HEATER & AIR CONDITIONER

SECTION HA

MODIFICATION NOTICE:

REFRIGERANT SYSTEM PROTECTION

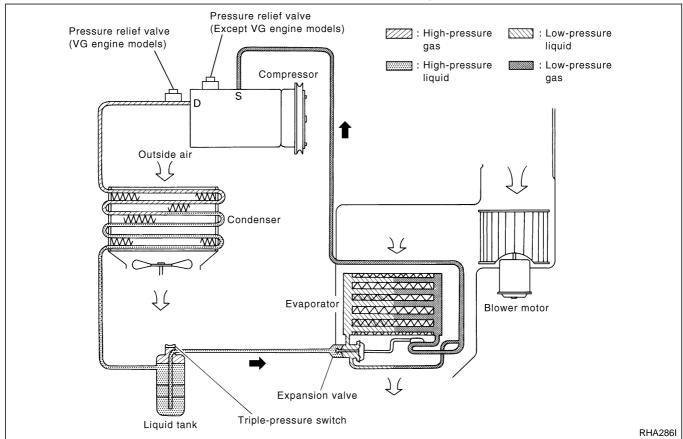
The refrigerant system is also protected by a pressure relief valve located on the compressor (Except VG engine models) or high-pressure flexible hose (VG engine models). When the pressure of refrigerant in the system increases to an unusual level [more than 3,727 kPa (37.3 bar, 38 kg/cm², 540 psi)], the release port on the pressure relief valve automatically opens and releases refrigerant into the atmosphere.

Wiring Diagram — A/C, M —/LHD Models with KA, YD and ZD Engines

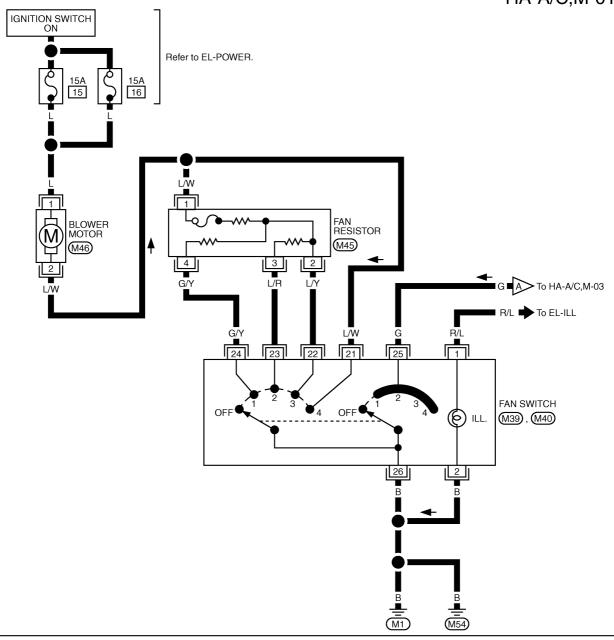
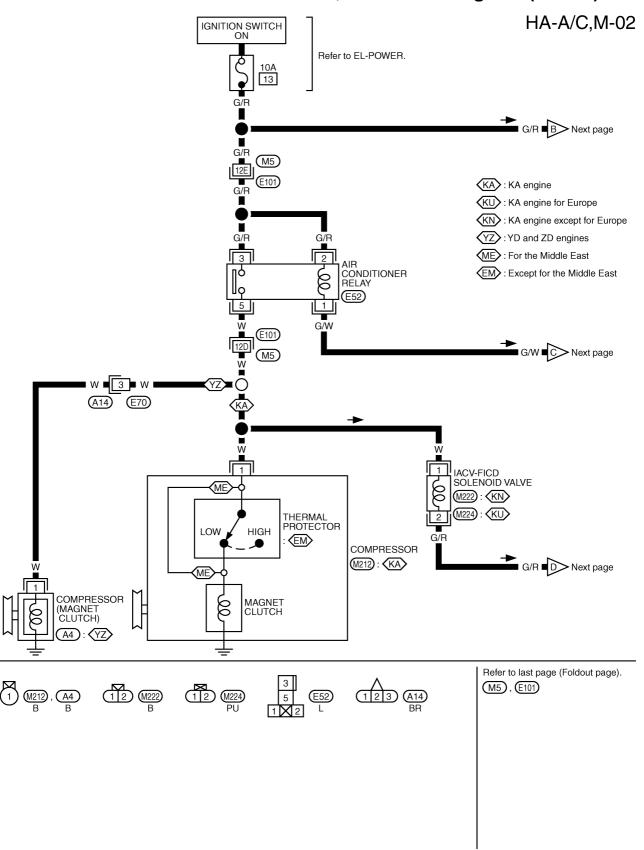
- Compressor has been changed. (KA engine models)
- Refrigerant amount has been changed.
- Fusible plug attached to liquid tank has been deleted.
- Pressure relief valve has been added to compressor.
- Wiring diagrams have been changed.
- Thermo control amp. of auto A/C has been abolished and trouble diagnosis of magnet clutch has been changed.
- Pressure relief valve has been added to compressor. (KA24DE and YD25DDT engine models)
- Refrigerant amount has been changed. (YD25DDT engine models) Refer to SDS.
